The Great Grid Upgrade

Norwich to Tilbury

2023 Non-Statutory Consultation Feedback Report

AENC-NG-CNS-REP-0007

Figure 4.23- Basildon and Brentwood (and Chelmsford east of Ingatestone) section map

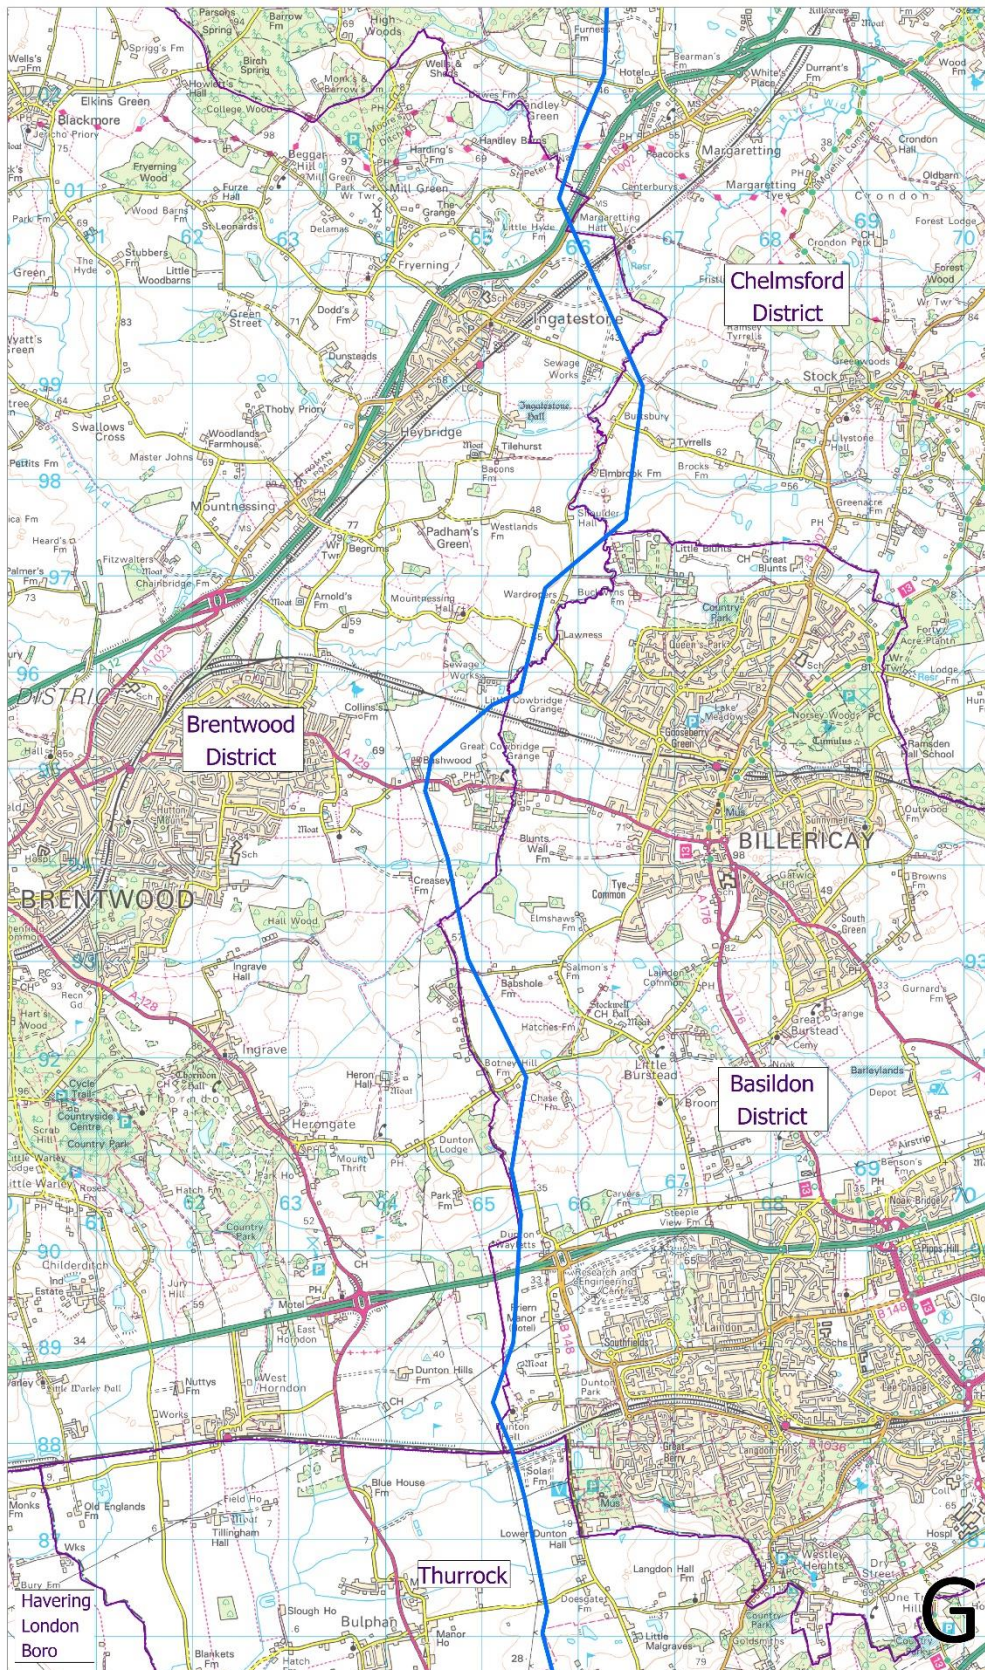
Ref no.	Summary of matters raised	National Grid’s response
Agricultural Land		
4.16.1	Concern that the Project will impact agricultural electric fencing due to electromagnetic fields, and request that National Grid fund any permanent non-electric fencing required as a result.	<p>The management and control of microshocks in the UK is set out in a Code of Practice produced by Government. This Code of Practice recognises that control of microshocks is not based on a simple quantitative limit. Rather, there is a suite of measures that may be called upon in particular situations.</p> <p>The Code of Practice provides a complete system for the control of microshocks, specifying what action is required to be taken, by whom, and under what circumstances. The Project has been designed in accordance with this Code of Practice which is incorporated in the National Grid policies and guidance. At the point that any proposed overhead line is operational, any residual microshocks that were reported would fall under the provisions of this Code of Practice and National Grid would mitigate in line with this guidance. This includes any impacts to agricultural electric fencing.</p>

Figure 4.24- Thurrock section map

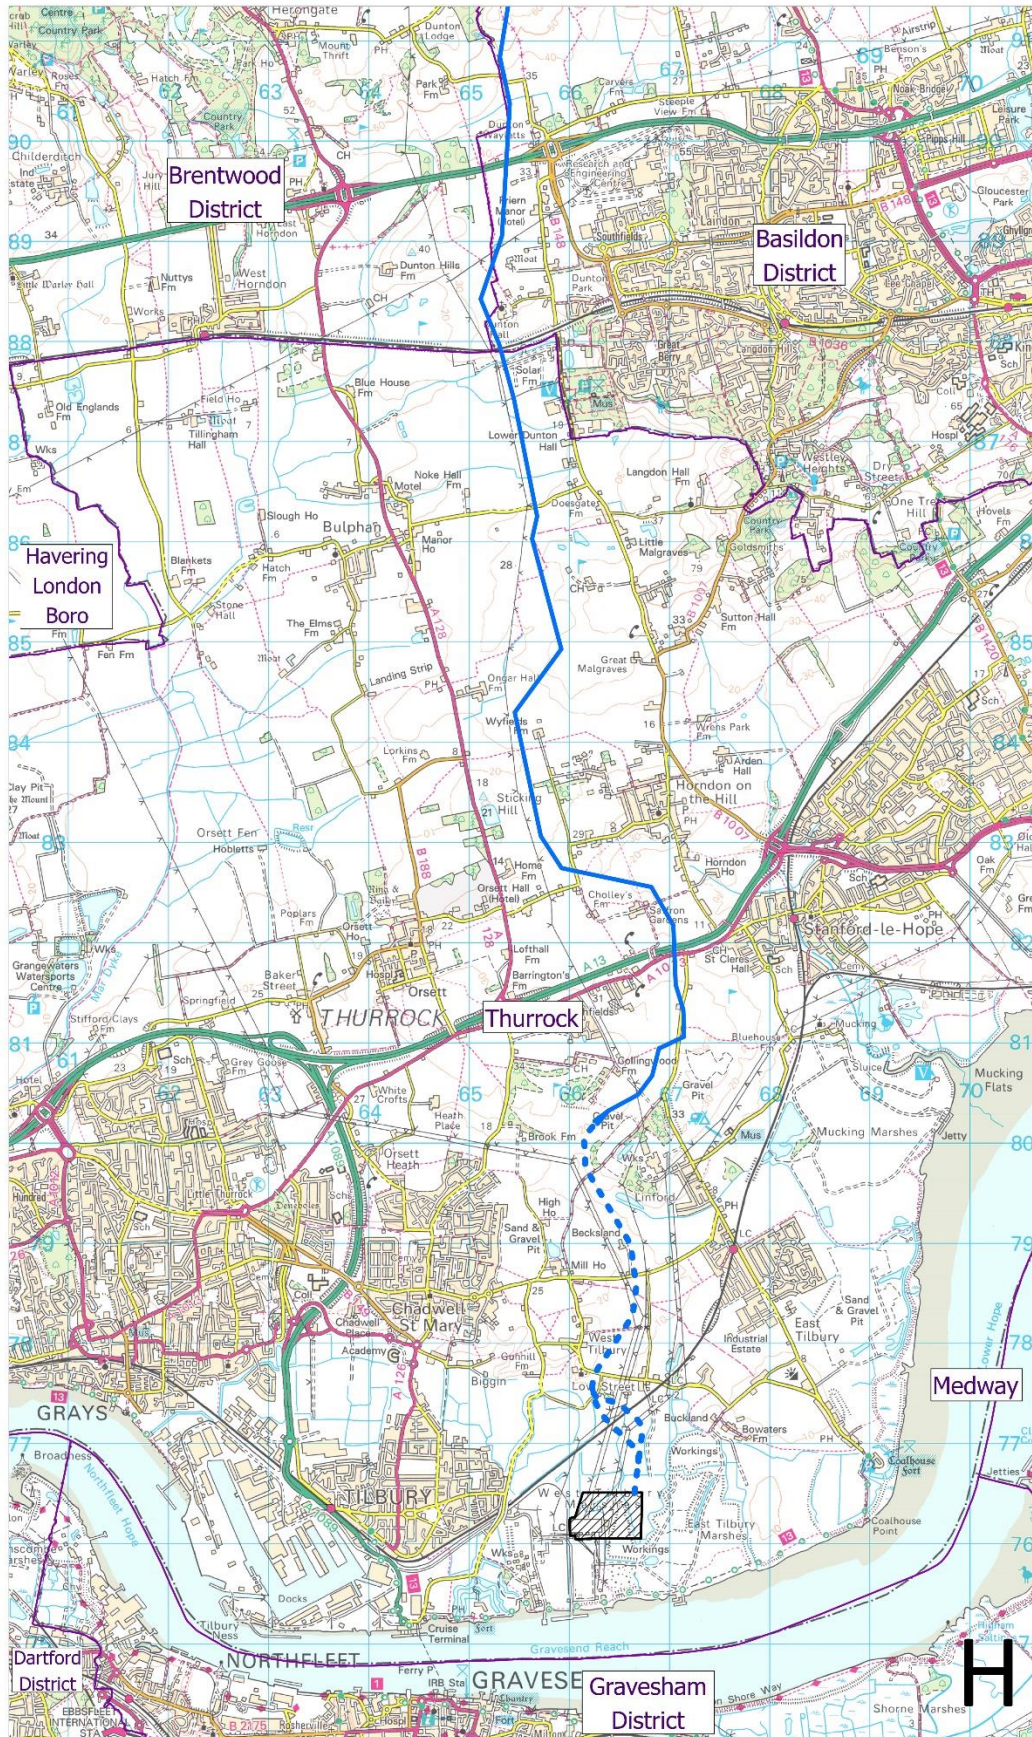
Ref no.	Summary of matters raised	National Grid's response
Agricultural Land		
4.17.1	Concern that the Project will take away valuable agricultural land / disrupt farming operations.	National Grid is and will continue to work with all landowners including farmers who may be affected by the proposals to understand the impacts on their operations and to work with them as the Project is developed. We will seek to work with the farming community to limit disruption where practicable. This includes providing prior warning of works which may result in the need to move livestock. Compensation claims for disturbance are considered on a case-by-case basis, if negative impact on farming operations can be proven. Particular agricultural matters can also be addressed through voluntary land agreements.
